From: sedna101@aol.com
Sent: Friday, June 23, 2017 12:35 AM
To: MN_COMM_Pipeline Comments
Subject: NO PERMIT. SHUT DOWN LINE 3 AND DEVELOP RENEWABLE ENERGY INFRASTRUCTURE.

The Draft Environmental Impact Statement (DEIS) for the Line 3 pipeline attempts to justify why the oil industry's need to profit is greater than the need of the Anishinaabeg people to survive.

Jamie MacAlister, Planning Director
Minnesota Department of Commerce
85 7th Place East Suite 500
St Paul, MN 55101

Enbridge is providing these initial comments identifying certain proposed discrete changes to the DEIS. To simplify the process of addressing these issues, Enbridge has organized these comments in the attached table (Attachment A). The table provides the statement or section of the DEIS being addressed, a citation to where it appears in the DEIS, and the proposed change, with a citation to the record or other source for the change, as appropriate.

Figure 1. Dakota Tallgrass Prairie Wildlife Management Area (Source: FWS, 2013)

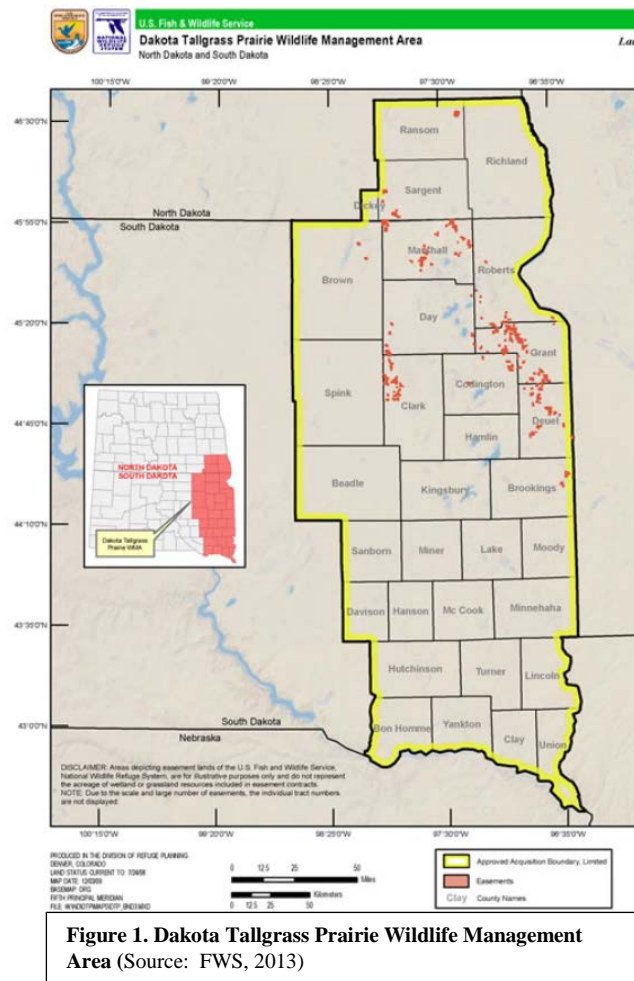
Because SA-04 would cross the Dakota Tallgrass Prairie Wildlife Management Area in Richland, North Dakota (see figure 1), it is probable that there would be impacts to rare grassland / prairie communities and species in North Dakota. The DOC-EERA could confirm that the data from the North Dakota NHI review (cited as NDGFP, 2016) have been incorporated into tables M-1 through M-3, as there are no species from North Dakota indicated within the construction workspace, operations right-of-way, or within 0.5 mile of the either the APR or any CN Alternatives. The DEIS indicates that SA-04 would impact 794 acres of the Dakota Tallgrass Prairie Wildlife Management Area (WMA) in table 5.2.4-11 of section 5.2.4.3.3. The Dakota Tallgrass Prairie WMA is a unit of the U.S. Fish and Wildlife Refuge System and was established in 2000 specifically to preserve quality tallgrass prairie habitat in southeastern North Dakota and

Figure 2. North Dakota State Wildlife Action Plan - Sand Deltas and Beach Ridges Focus Area (Source: Dyke et al., 2015)

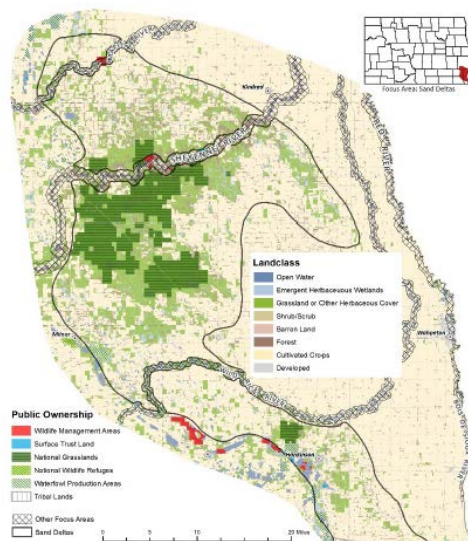
Tallgrass prairie was historically found primarily in the eastern quarter of North Dakota along the Red River Valley, and has been largely converted to agricultural lands. The area crossed by SA-04 is also identified as the Sand Deltas and Beach Ridges focus area for native tallgrass prairie preservation and conservation of associated wildlife in the North Dakota Wildlife Action Plan (WAP) (Dyke et al., 2015) (see figure 2).
